IFB NO. DACA51-01-B-0006
Amendment No. 1

AMENDMENT NO. 1 TO SPECIFICATIONS DATED 1 FEBRUARY 2001 FOR VETERINARY TREATMENT FACILITY, FORT
DRUM, NY

Amendment No. 1

VETERINARY TREATMENT FACILITY-KENNEL OFFICE BUILDING

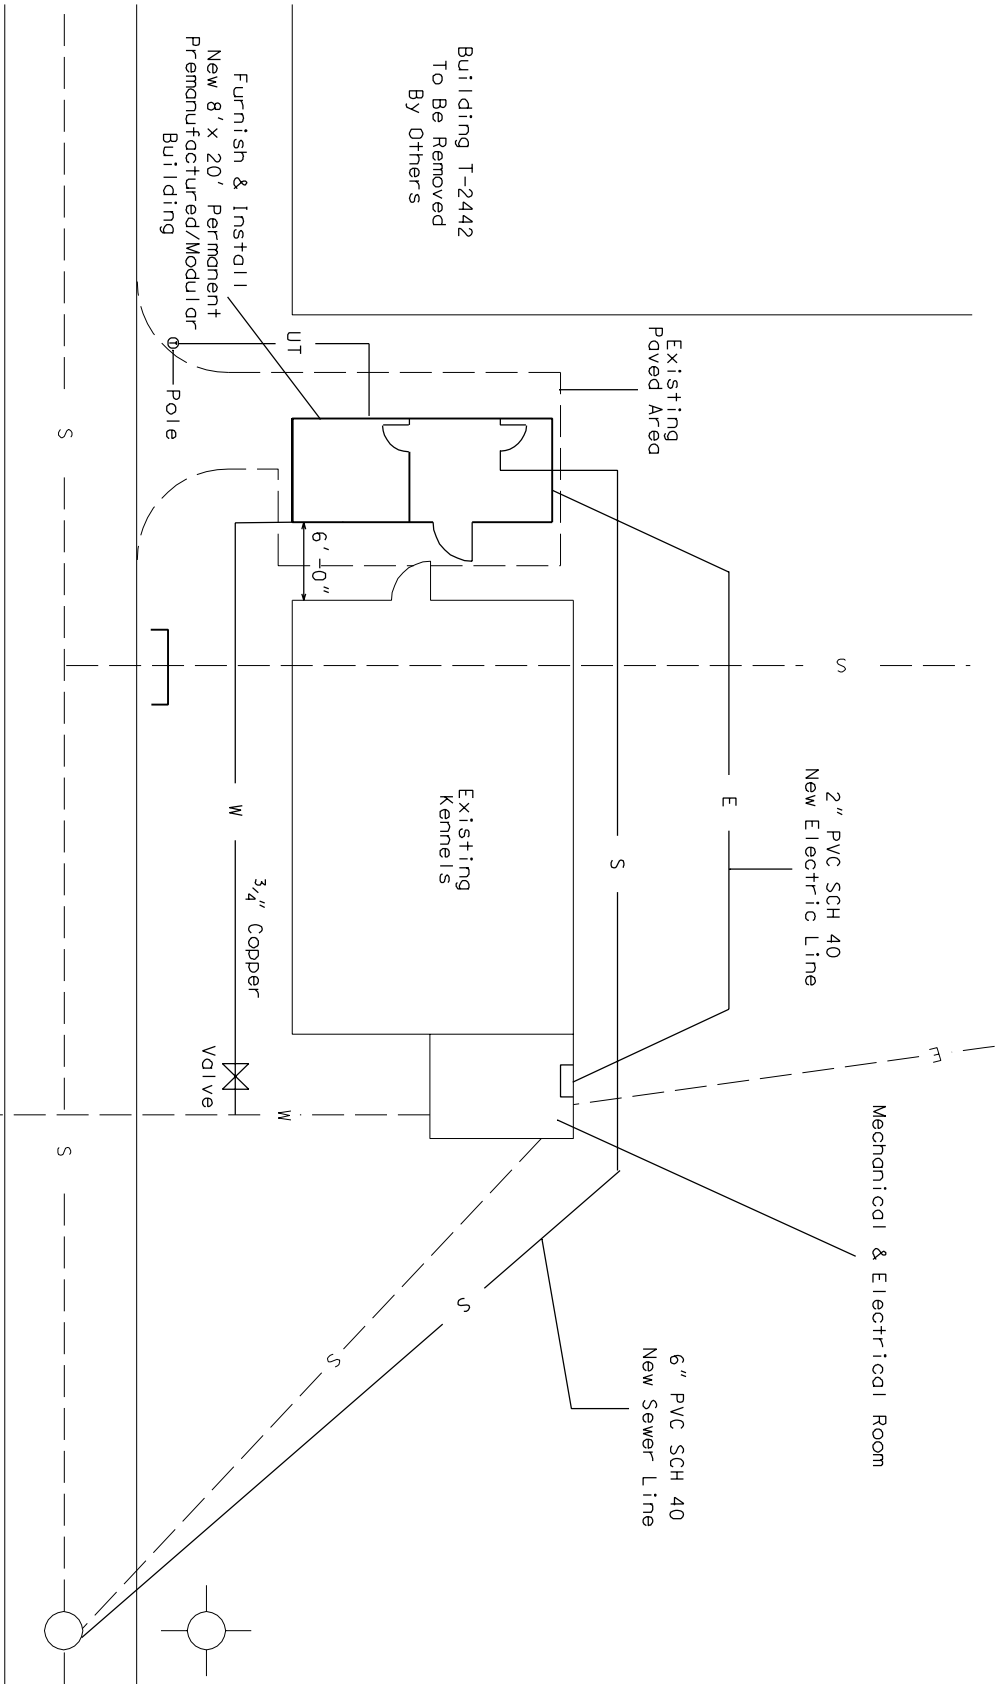
1. Section 00800, insert this page and the following three pages of this amendment as Paragraph 40 of this section. The following pages describe the permanent pre-fabricated/modular building that is to be Contractor provided and installed.

- Furnish and install a new, minimum size 8'x 20', permanent, pre-fabricated/modular building, white in color.
- The pre-fabricated/modular building will be well-constructed, insulated, water tight and properly ventilated.

- The pre-fabricated/modular building shall be anchored with rods and cable or by steel straps to ground anchors (hurricane straps); the anchor system shall be designed to withstand winds and meet applicable state and local standards for anchoring modular buildings.

- ½ Bath
- One main entrance with insulated lockable door, a partitioned room for bathroom with lockable door, and a partitioned office with lockable door.

- Pre-fabricated/modular building shall be blocked up approx. 1 foot minimum above ground and be level.
- Pre-fabricated/modular building shall be provided with steps that are of aluminum construction, non-slip surface, and that meet OSHA safety parameters.

- Pre-fabricated/modular building to be fully skirted with quality metal consistent to the building.
- Pre-fabricated/modular building to be insulated and have minimum 26 gauge, colored metal siding, 1/8 inch thick VCT flooring. V Blinds, wood grain interior paneling, white finished ceiling (easily cleanable), operable windows with locks, and doors where indicated on floor plan.

- Provide adequate electric florescent lighting with switches.
- Provide minimum 7 duplex electrical receptacles, one of which to be located in bathroom and be GFCI rated.
- Minimum 2 phone jacks in office and direct buried line to power pole and connect to existing line.
- Provide minimum 40 amp electrical underground service and panel in the building (120/220V) consistent to existing panel
- Connect new electrical service to the existing kennel electric panel

- Provide 10 gallon electric hot water heater in bathroom connected to sink
- Heat trace and insulate all water lines to prevent freezing.
- Water lines shall be installed minimum 5 ft below ground.
- Connect to existing water line and provide with valve and valve box at connection point
- Connect sewer line to existing system manhole

- Provide gas (propane) fired heat for pre-fabricated/modular building.
- Provide 6" thick reinforced concrete pad large enough to hold Government provided 500 gallon propane tank and 4, 4 inch diameter, 4 ft high steel bollards above grade and 4 ft below grade, set in concrete. Prime and paint bollards yellow.
- Provide copper gas piping and connection to propane tank.
- Provide exhaust fan in bathroom
